MIDLAND UNITS 1 & 2
JOB NO. 7220

REVIEW OF U.S. TESTING
FIELD AND LABORATORY CONSTRUCTION
TEST DATA ON SOILS USED AS FILL

PREPARED BY
BECHTEL POWER CORPORATION
JUNE 12, 1979

FIGURE 1

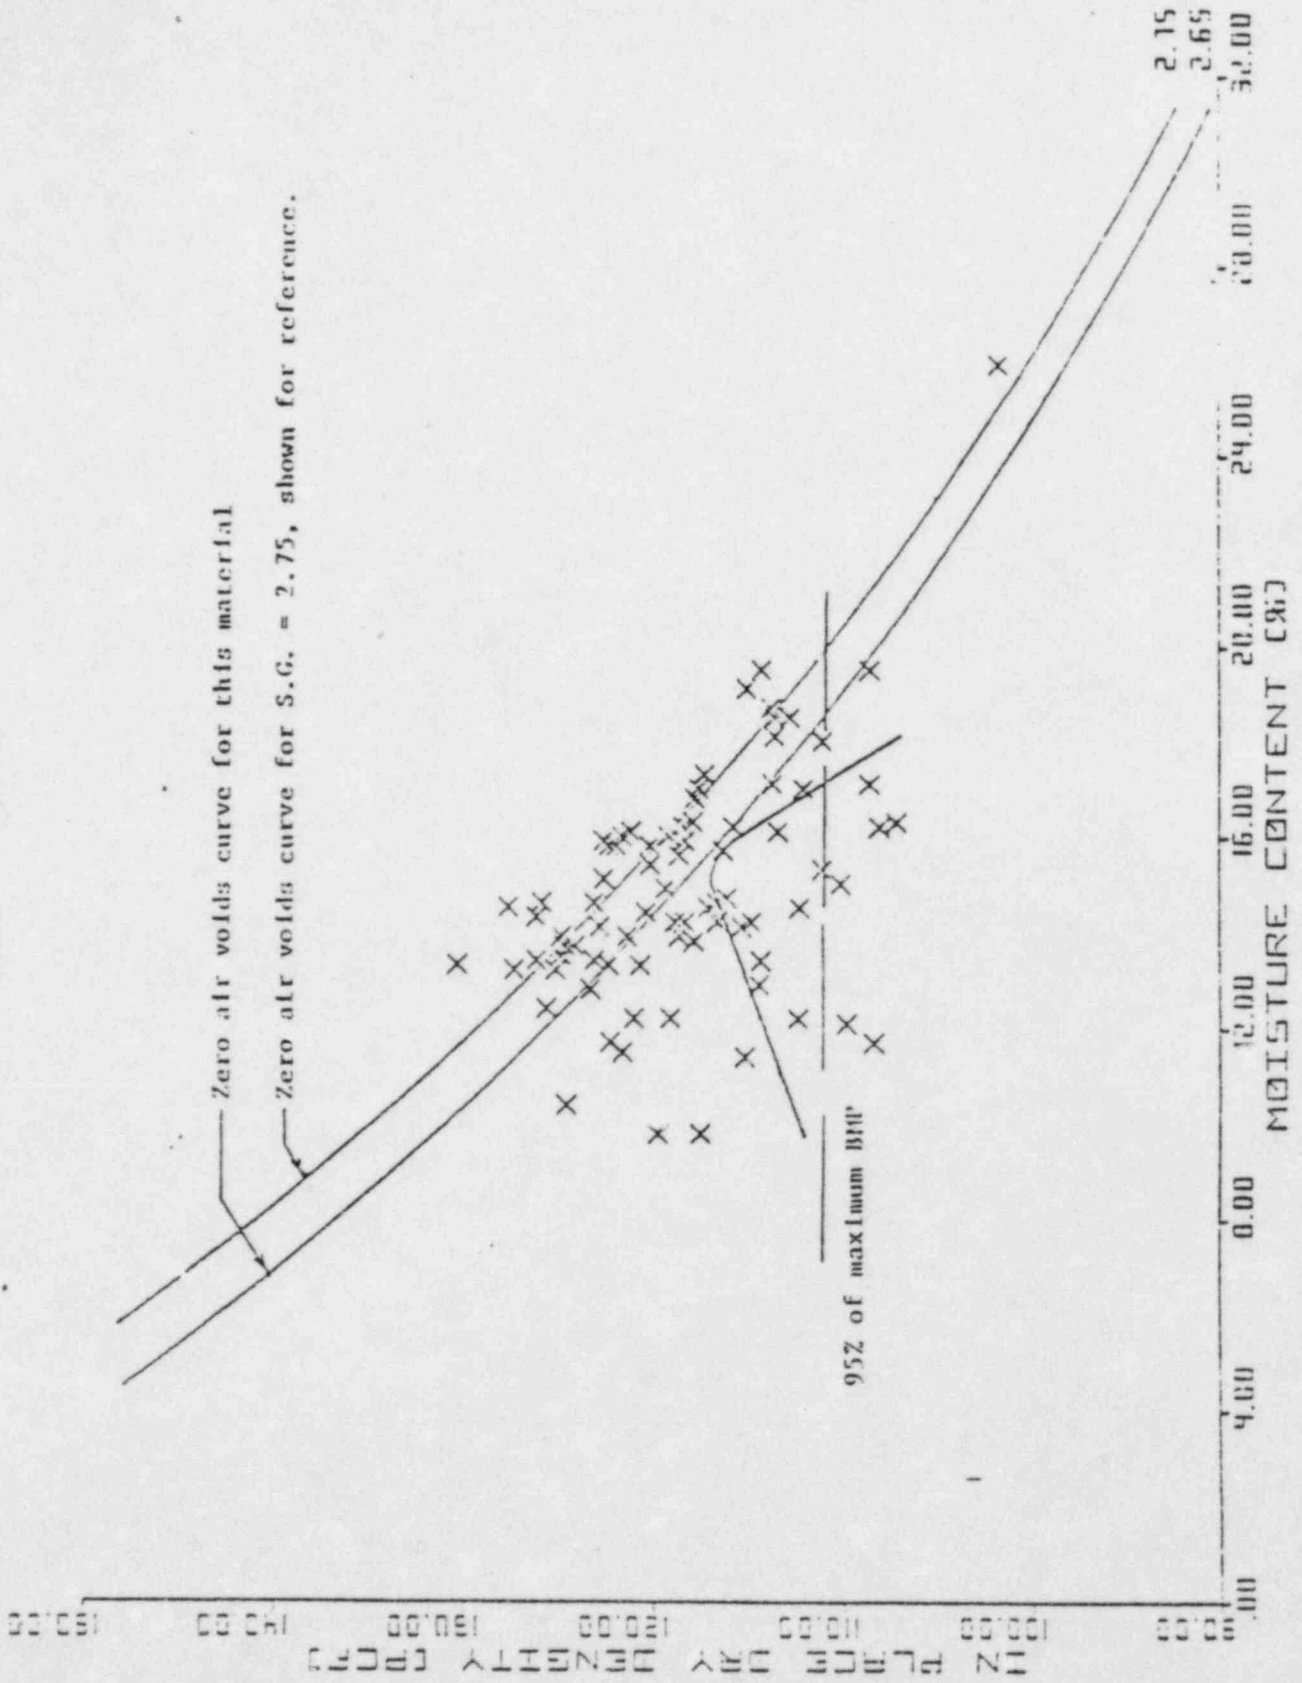
Also, referring to Figure 1 it would appear that soil density varied widely. Specifications called for compactive effort results as defined by ASTM D 1557 which is 56,255 ft-lb/ft³ energy. This was modified to a laboratory test compactive effort of about 20,000 ft-lbs/ft³ energy, often referred to as Bechtel Modified Proctor (BMP). Laboratory compaction test curves should be related to the same effort as that called for in the field for use in comparing with field density tests. According to plots of field data shown on Figure 1, density varied from about 108 lbs/ft³ to about 130 lbs/ft³. It is doubtful that the soil classification or other properties would be similar for such a wide variation in density. It is noted that 100 percent of modified Proctor (ASTM D 1557) which is difficult to obtain, is rated at 56,255 ft-lbs/ft³ energy. The curve plotted on Figure 1 is at about 20,000 ft-lbs/ft³ energy. For comparative purposes it was determined by U. S. Testing in 1974 that 100 percent of specified effort (20,000 ft-lbs/ft³) is approximately equal to 95 percent of the maximum density as determined by ASTM D 1557 (56.255 ft-lbs/ft³) Reference Figure 3. This means that a density up to 5 percent greater (dry density of 123.2 lbs/ft³) than that specified (dry density of 117.0 lbs/ft³) could be possible. However, some points shown on Figure 1 give an apparent density up to 11 percent above that specified.

FIGURE 3

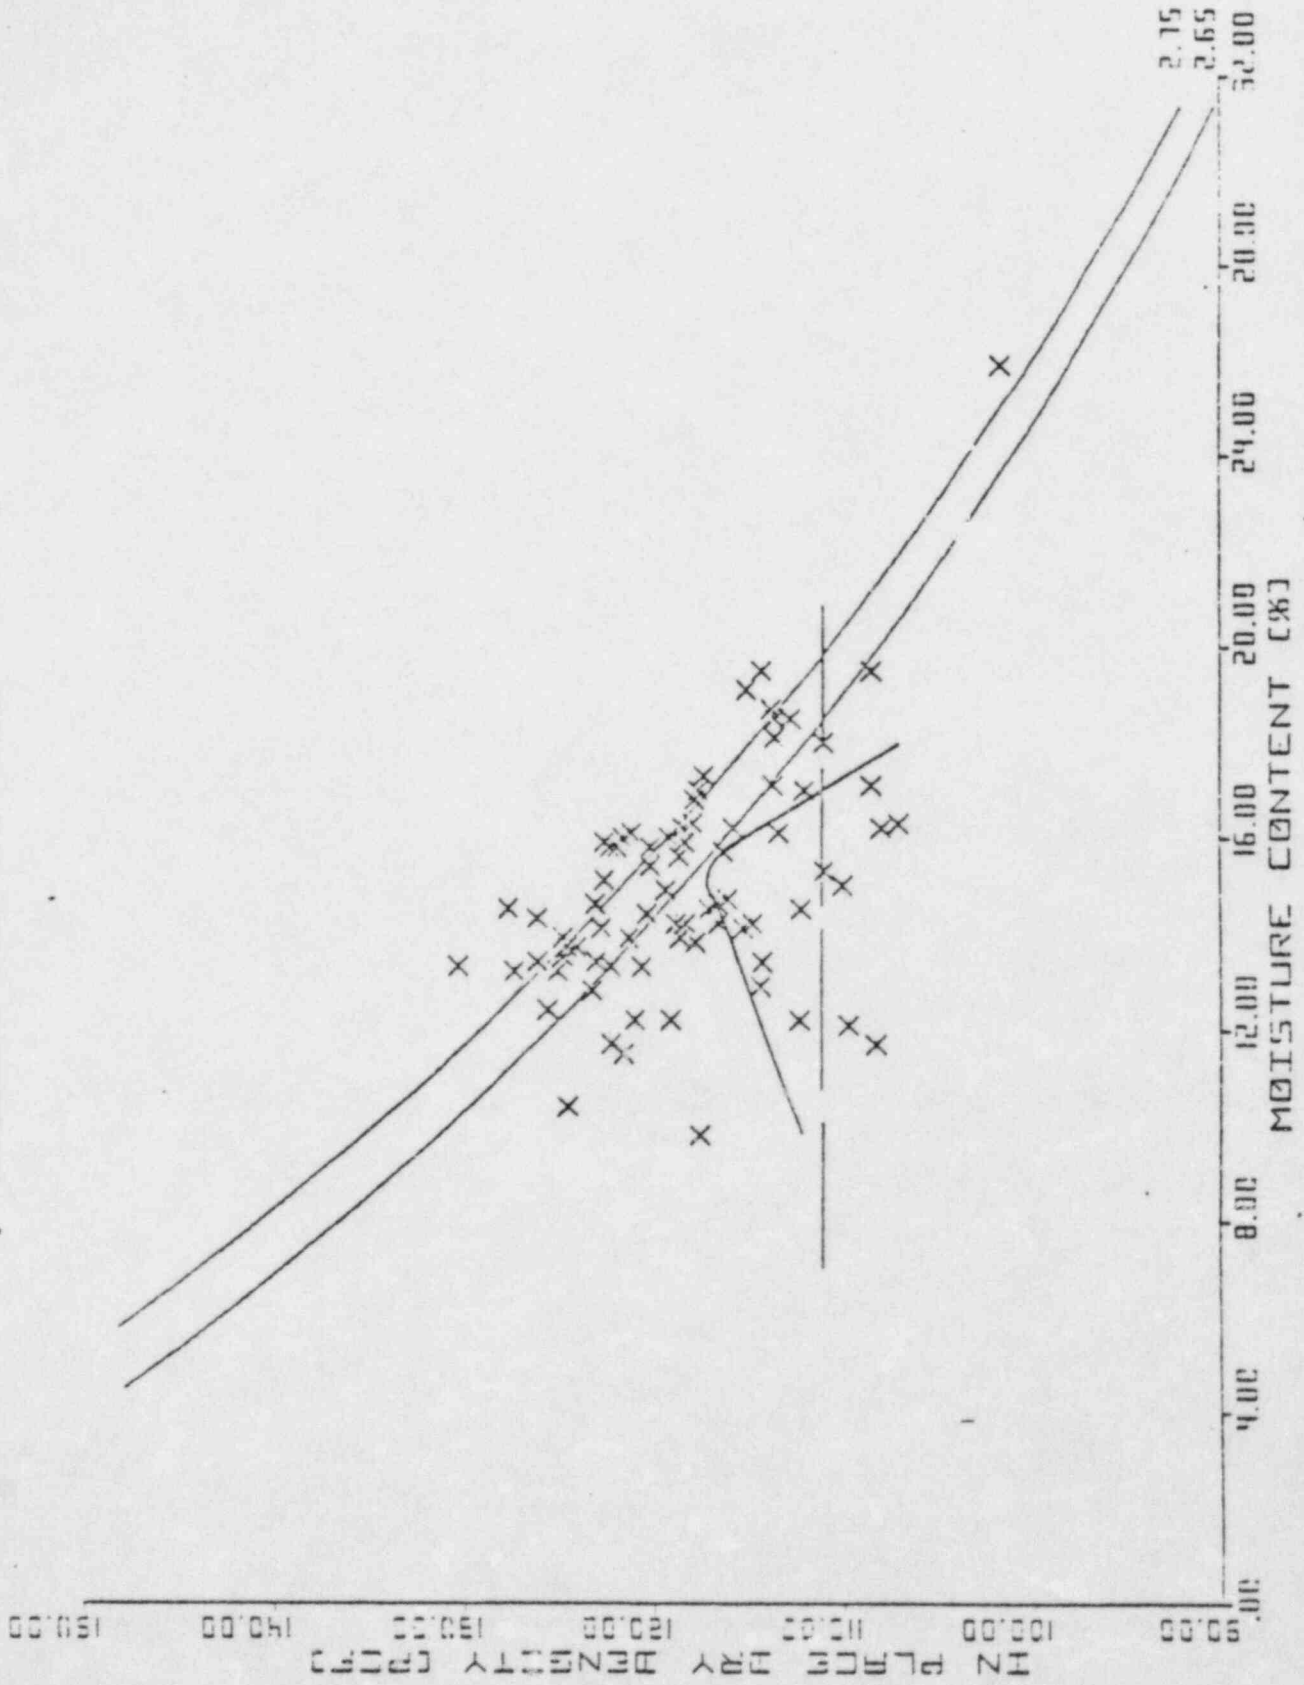
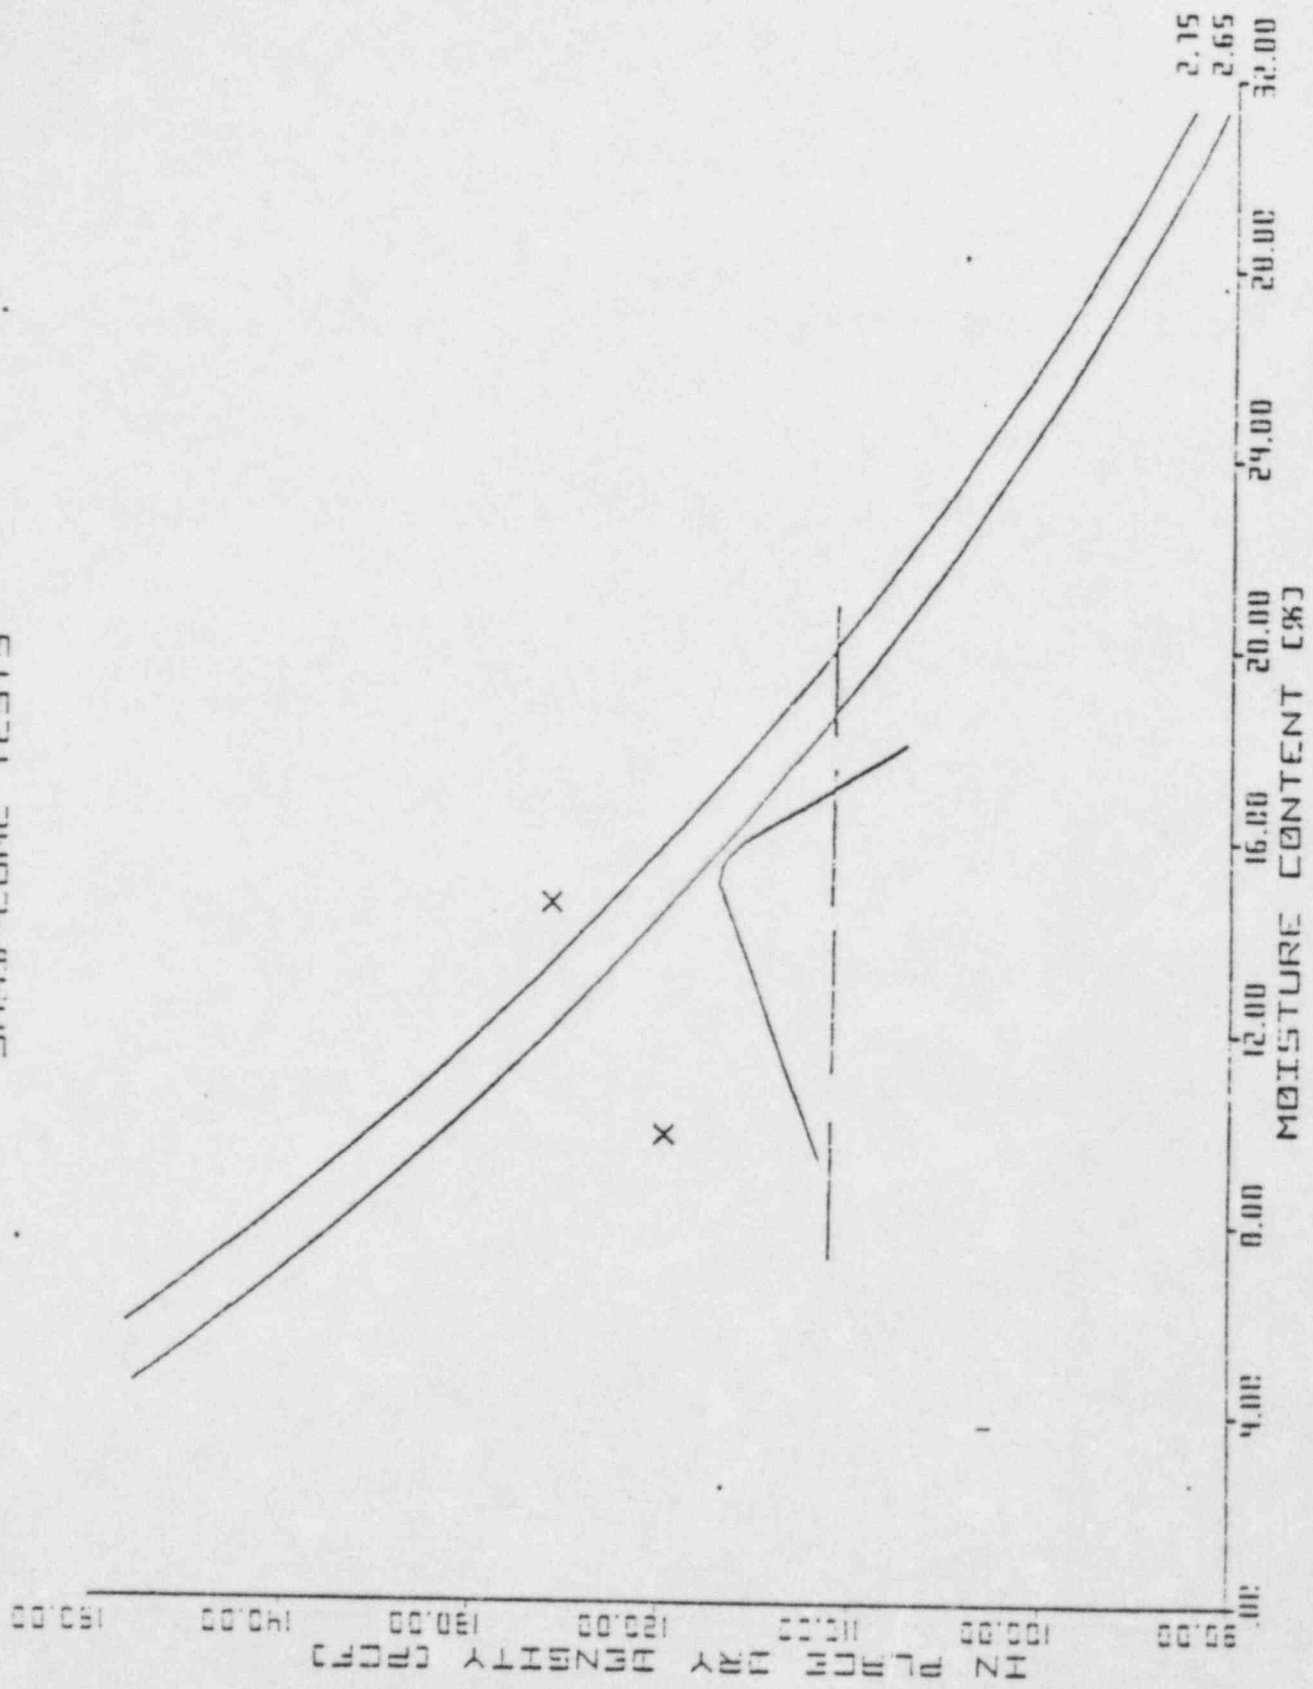
Plots of field data for compaction test BMP 278 are shown on Figures 1 through 6. The title of each figure gives the assumptions made in plotting data for the figure. In comparing figures 3 and 4 it is seen that a majority of field tests were made using the nuclear device. The two test results shown on Figure 4 for the sand cone method indicates one test result on each side of the zero air voids curve. The one falling above the zero air voids curve (shown on Figure 4) is designated by U. S. Testing Company as the only passing sand cone test (shown on Figure 6)

FIGURE 7: WINDOWS OF ACCEPTABILITY (A) BASED ON BMP SPECIFICATION (B) REGARDLESS OF EXACT WORDING OF SPECIFICATION

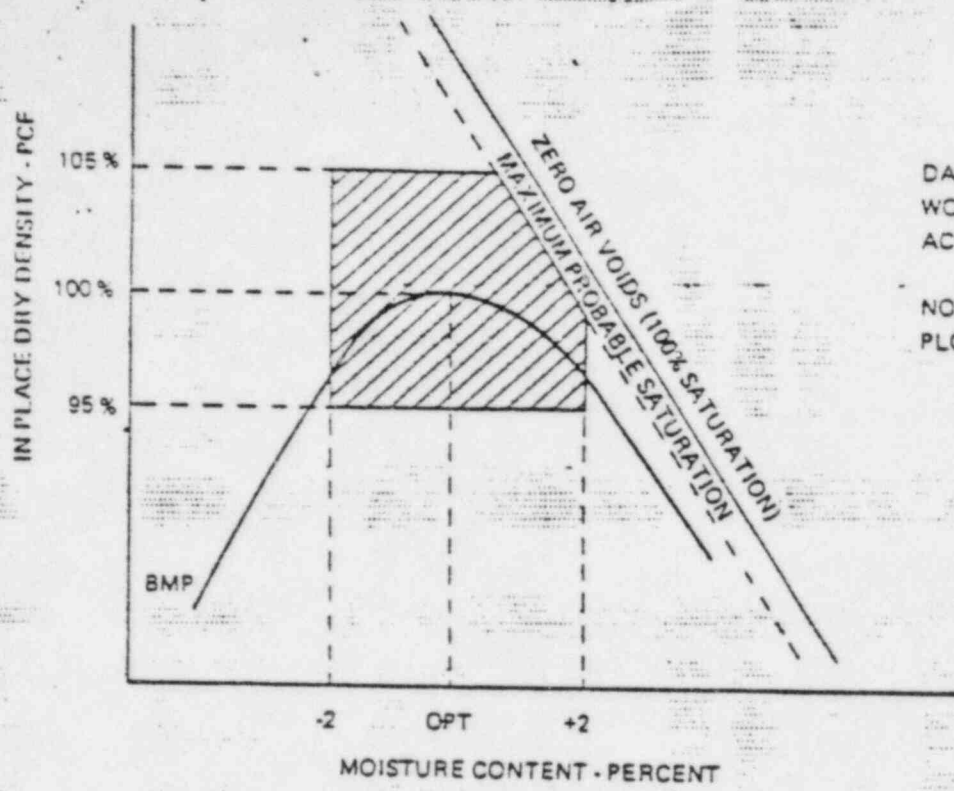
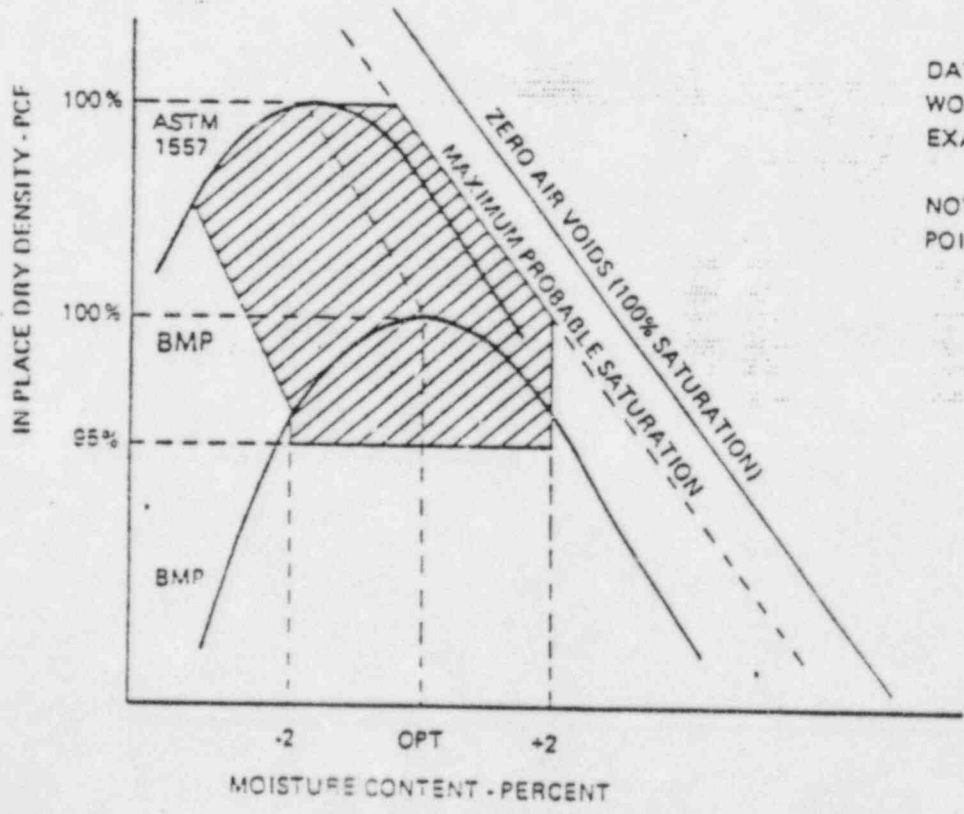
For a field test result to be valid as well as "Passing" it must fall within a well defined area on the plot containing the laboratory compaction curve. This area or window of acceptability is shown for a hypothetical compaction curve on Figure 7a that would meet requirements of Specification 7220-C-210. It is defined by horizontal lines at 95 percent and 105 percent of specified density, vertical lines through ± 2 percent of optimum moisture content, and a line parallel to the zero voids line indicating saturation about half way between the compaction curve and 100 percent saturation (zero air voids curve). The upper limit of 105 percent of specified density is not defined in the specifications. It was arbitrarily chosen as an upper limit since engineers knowledgeable in soil compaction have observed that numbers greater than this give increasingly invalid comparisons between field test results and the specified laboratory test curve. Therefore, if all data points fall within the defined window there would be no reason to assume that they are wrong. However, when many data points fall outside the designated area there is something wrong with the information and then all data points become suspect. A review of all data indicates that about 25 percent of the cohesive soil test results fall within this area.

Figure 7B shows an area where field test results would be acceptable, in theory even though not in strict accordance with the specifications. Figure 7B was arrived at by expanding Figure 7a to include test results up to a compactive effort related to ASTM D 1557 (56, 255 ft.-lbs/ft. 3) which is considered to be a practical upper limit. About 40 percent of all cohesive soil test results would plot in this area.

DATA POINTS THAT PLOT IN SHADED AREA WOULD BE GENERALLY ACCEPTABLE ACCORDING TO SPECIFICATIONS

NOTE: ABOUT 25% OF ALL FIELD DATA PLOTS IN THE SHADED AREA

DATA POINTS THAT PLOT IN SHADED AREA WOULD BE ACCEPTABLE REGARDLESS OF EXACT SPECIFICATION WORDING
